PANAMA CANAL AUTHORITY		VARIATION	PAGE 1 OF 3
1. REQUEST FOR PROPOSAL No.:	2. CONTRACT No.:	3. DATE:	September 28, 2012
RFP-76161	CMC-221427	4. VARIATION No.:	050

Variation No. 050 is issued to incorporate the following:

THIRD SET OF LOCKS - PACIFIC SIDE
CONSTRUCTION MANAGEMENT TEAM
COCOLI - BLDG. #326

TITLE: AREA REQUESTED TO BE USED BY HYUNDAI
SUBCONTRACTOR

SKE-P-CM-MIC-007

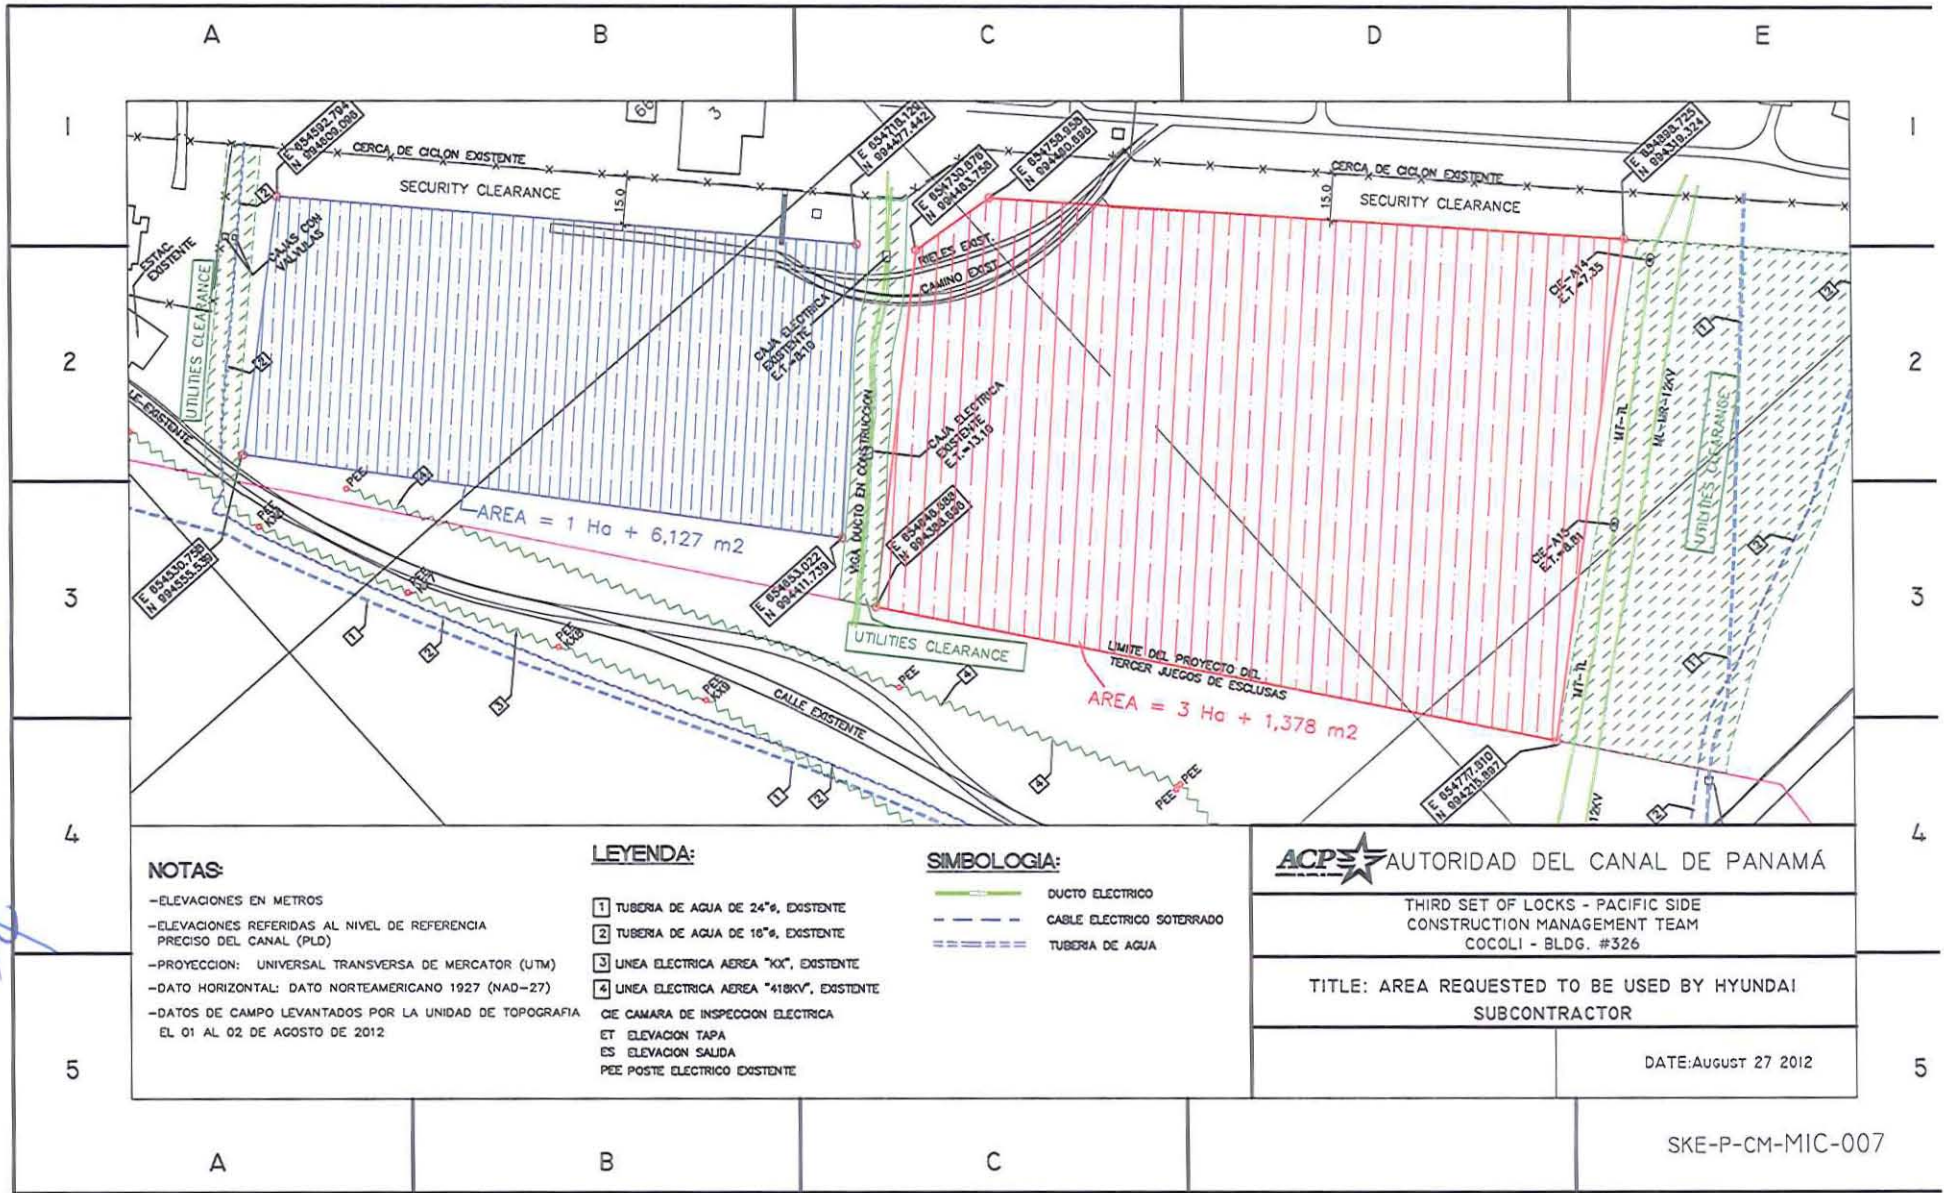
4. At the Pacific Site, extend the Contractor's limits to the two additional storage areas depicted on the attached sketch SKE-P-CM-MIC-007 and which are bounded by the following coordinates:

Before any work is started in the above areas:

- a development plan, which, at a minimum, should indicate all structures to be erected and include a grading and drainage plan, must be prepared and submitted to the Employer for review,
- the Contractor must clearly mark the limits of the two new areas and erect perimeter fences to ensure that all activities stay inside the above defined boundaries, and
- the Contractor must comply with the requirements established in the relevant Sections of the Employer's Requirements.
